PRODUCT SUPPORT BULLETIN BULLETIN NO. 315

MACHINE: **Auto-Lift**

SUBJECT: **Propel Switch Kit – 98790019**

**Screw Mounted Switch
5125426
(supplied in kit 98790019)**

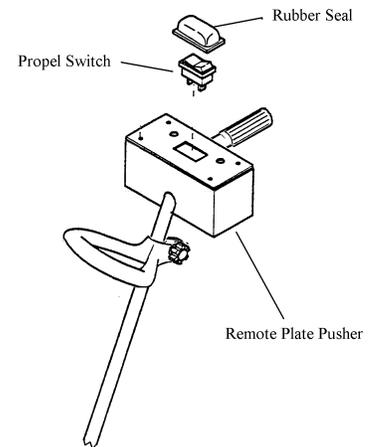
This problem is caused by 2 factors. First, if the rubber seal, p/n 67920020 over the switch becomes damaged, the boot can wedge under the rocker of the switch causing it to jam in the “ON” position. To eliminate this possibility, **NORDCO recommends that this seal be removed.** Because the switch is sealed internally, this will not cause a problem with the switch operation.

Second, the current switch is a “bezel mount” style switch. There have been some cases of the switch becoming twisted in the mounting hole and causing the switch to become jammed in the “ON” position. To eliminate these possibilities, the current Propel Switch will be replaced by **Propel Switch Kit, p/n 98790019.** This kit includes a **screw mounted Propel Switch, p/n 5125426, mounting hardware and instructions.** Two mounting holes must be drilled in the Remote Plate Pusher Assembly or Operators Control Box on the machine to mount this new switch.

Both switches will be available only until current inventory of the 5125599 switch is exhausted. After that, only the 98790019 kit will be shipped.
